MIL-L-3661B
 AMENDMENT 4
 09 December 1991
 SUPERSEDING
 AMENDMENT 3
 17 February 1972

MILITARY SPECIFICATION

LAMP HOLDERS, INDICATOR LIGHTS, INDICATOR-LIGHT HOUSINGS,
 AND INDICATOR-LIGHT LENSES,
 GENERAL SPECIFICATION FOR

This amendment forms a part of MIL-L-3661B, dated 27 March 1967, and is approved for use by all Departments and Agencies of the Department of Defense.

CANDELABRA BAYONET LAMP SOCKETS
FIGURE 1. Moving Contacts

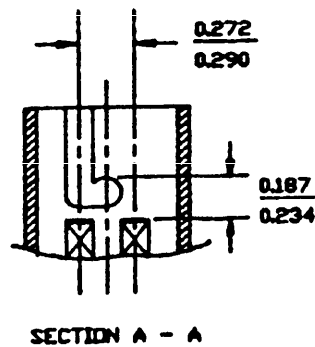
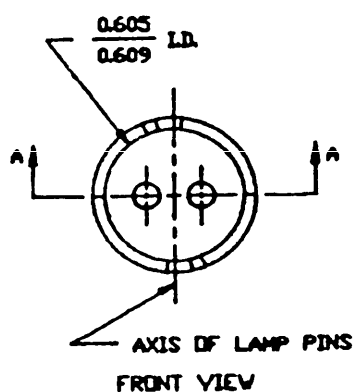
Paragraph 3.4.10.1.1, sixth and seventh lines: Delete and substitute "...sockets, and .187 inch minimum, .234 inch maximum for candelabra bayonet lamp sockets (see figure 1)."

Figure 1: Delete "Candelabra Lamp Sockets" figure and substitute the attached "Candelabra Bayonet Lamp Sockets" figure.

FIGURE 2. Midget and submidget flange base test plugs

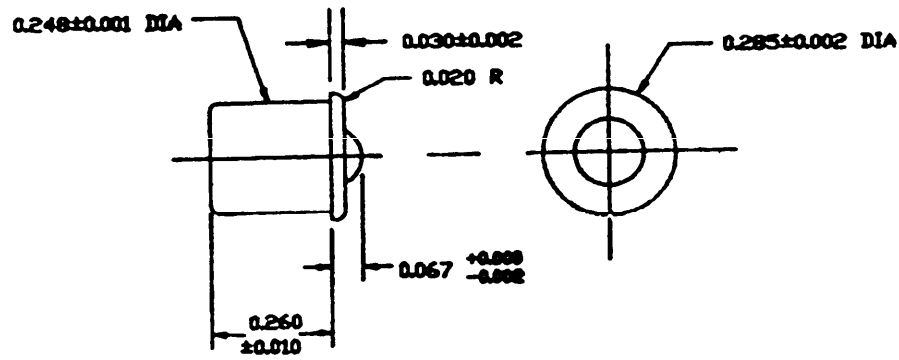
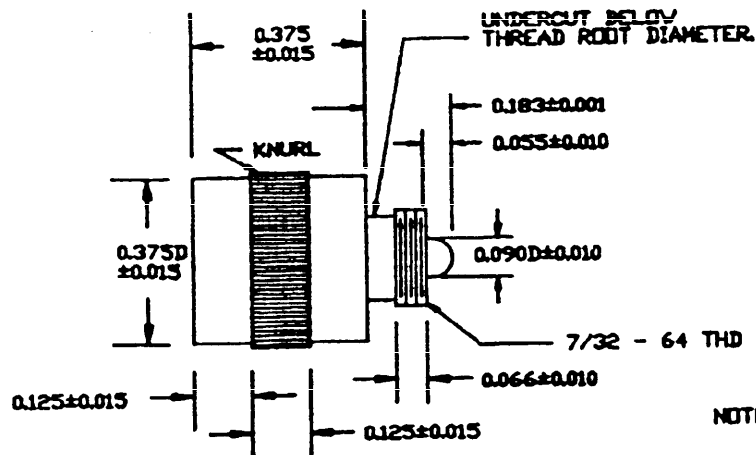
Figure 2: Delete and substitute the attached figure 2.

FIGURE 6. Test plugs for midget and submidget-flange-base-indicator-light housings (contact-spring-pressure test)

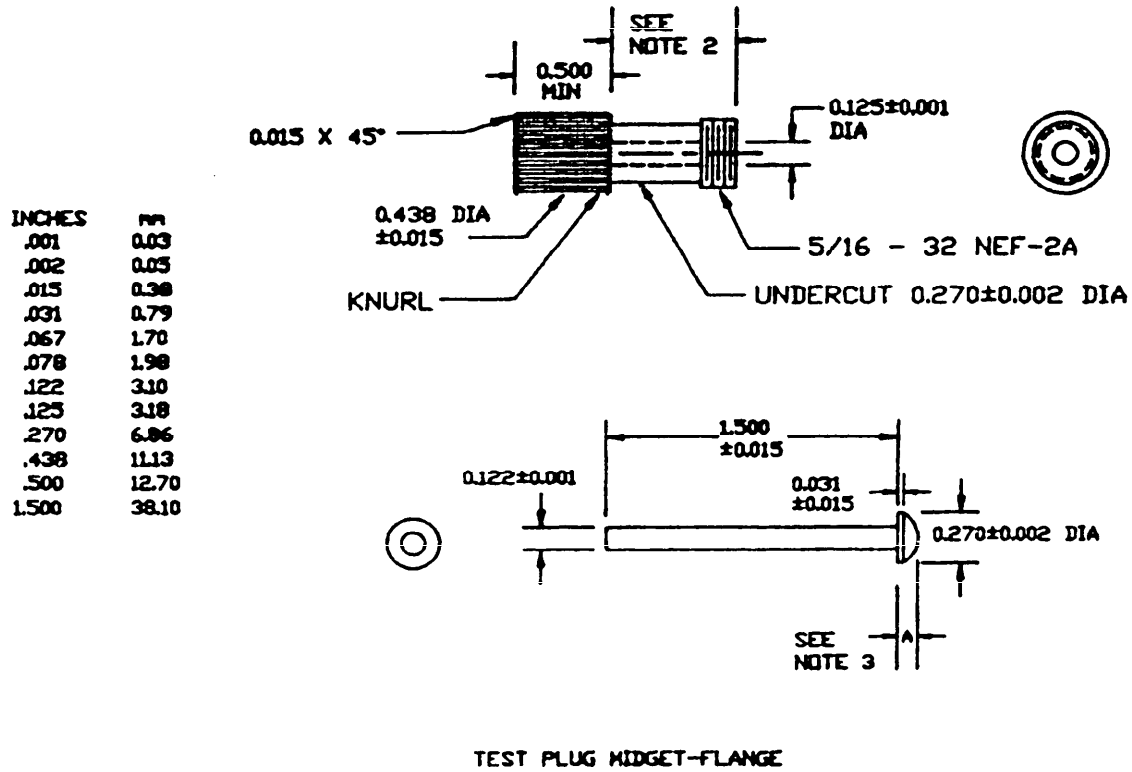
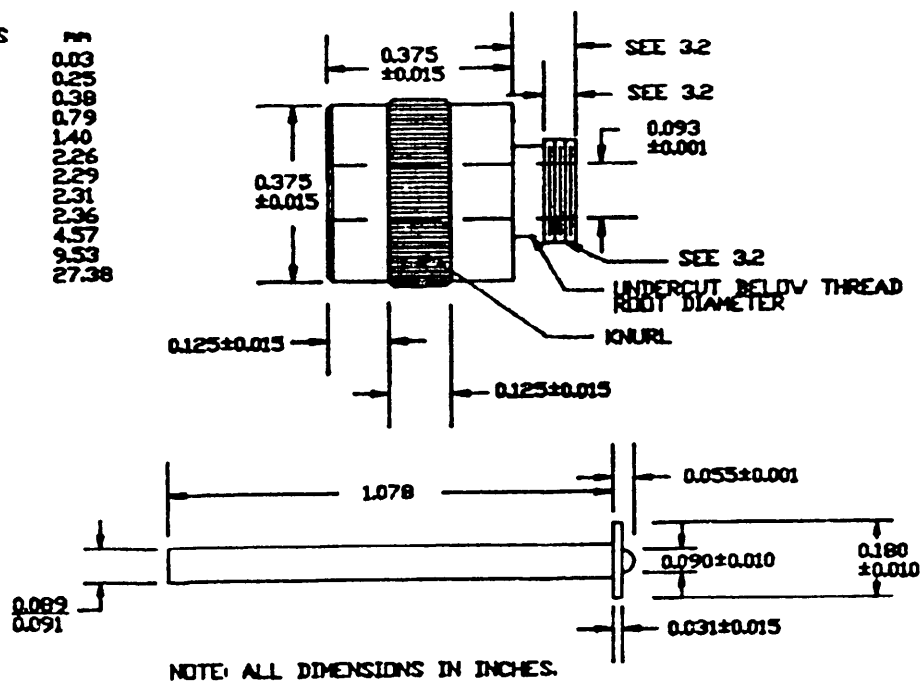
Figure 6: Delete and substitute the attached figure 6.
